Planning and Zoning Commission - Regular Meeting AGENDA

Tuesday, September 15, 2020 at 4:30 PM
Ketchum City Hall
480 East Avenue North, Ketchum, ID 83340

STAFF REPORT
KETCHUM PLANNING AND ZONING COMMISSION
MEETING OF SEPTEMBER 15, 2020

- PROJECT: 4th & Walnut Ave Commercial Development Design Review
- FILE NUMBER: P20-046
- APPLICATION TYPE: Design Review
- APPLICANT: Graham Whipple, Resin Architecture
- PROPERTY OWNER: Walnut & Fourth LLC
- LOCATION: 371 & 391 N Walnut Avenue (Ketchum Townsite: Block 44: Lots 7 & 8)
- ZONING DISTRICT: Retail Core Subdistrict of the Community Core (CC-1)
- NOTICE: The public hearing for this application was continued from the July 13th and August 11th Planning & Zoning Commission Meetings. The project was re-noticed for the public hearing scheduled on the agenda for the September 15th Planning & Zoning Commission Meeting. The public hearing notice for this project was mailed to all owners of property within 300 feet of the project site and published in the Idaho Mountain Express on August 26th, 2020.
- REVIEWER: Abby Rivin, Associate Planner

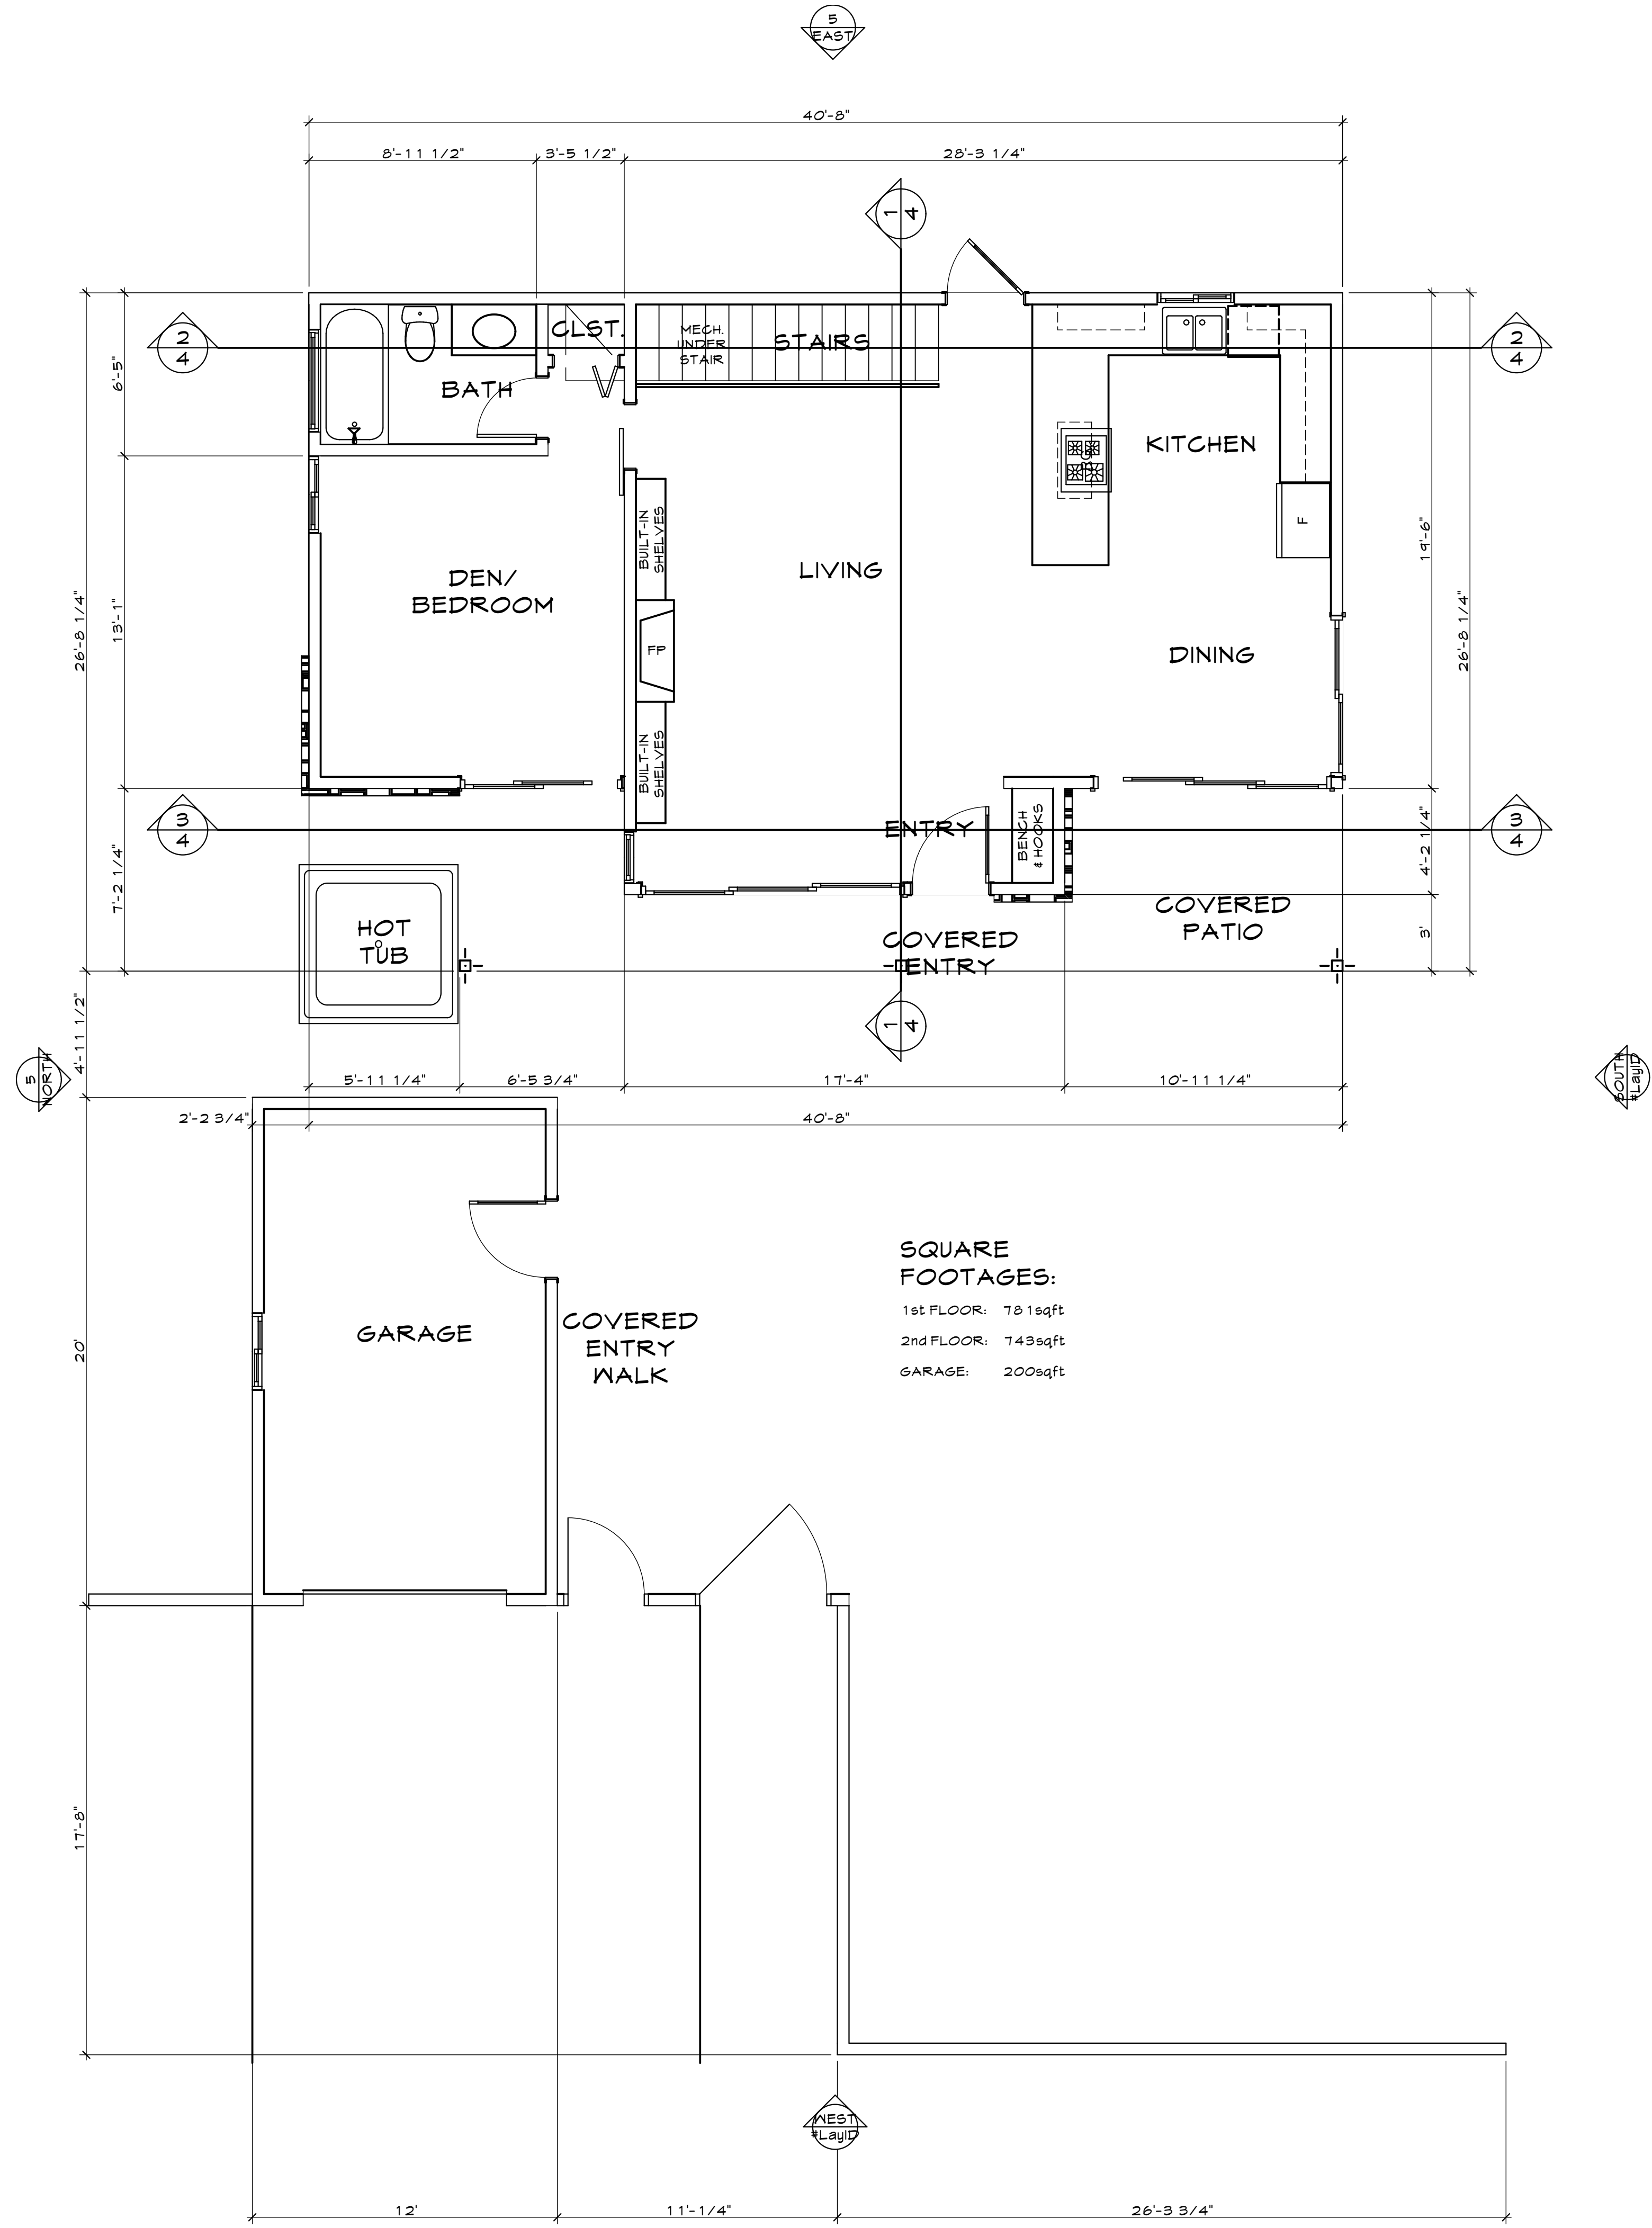
<p>on Sheet C1.0 of the project plans. The drainage plan proposes a system of drywells and catch basins.</p> <p>Prior to issuance of a Building Permit for the project, the applicant shall submit a final drainage plan indicating grading, catch basins, piping, and drywells (KMC §17.96.040.C.2b & KMC §17.96.060.C.1-4) prepared by a civil engineer licensed in the state to be submitted for review and approval by the City Engineer and Streets Department. See Exhibit C3 for City Department comments including City Engineer and Streets Department conditions.</p>
<input checked="" type="checkbox"/>	<input type="checkbox"/>	<input type="checkbox"/>	17.96.060.C2 Drainage	<p>Drainage improvements constructed shall be equal to the length of the subject property lines adjacent to any public street or private street.</p> <p><i>Staff Comments</i></p> <p>See above analysis for Ketchum Municipal Code §17.96.060C1. All drainage improvements are required to meet City standards.</p> <p>All drainage improvements shall be indicated on civil plans prepared by an Idaho licensed engineer and require review and approval from the City Engineer & Streets Department prior to issuance of a Building Permit for the project.</p> <p>See Exhibit C3 for review comments and conditions from the City Engineer & Streets Department.</p>

<input checked="" type="checkbox"/>	<input type="checkbox"/>	<input type="checkbox"/>	17.96.060.D1 Utilities	<p>All utilities necessary for the development shall be improved and installed at the sole expense of the applicant.</p> <p><i>Staff Comments</i></p> <p>All utilities necessary for the townhome project must be improved and installed at the sole expense of the applicant. The applicant has submitted the preliminary utilities plan on Sheet C1.0 of the project plans.</p>
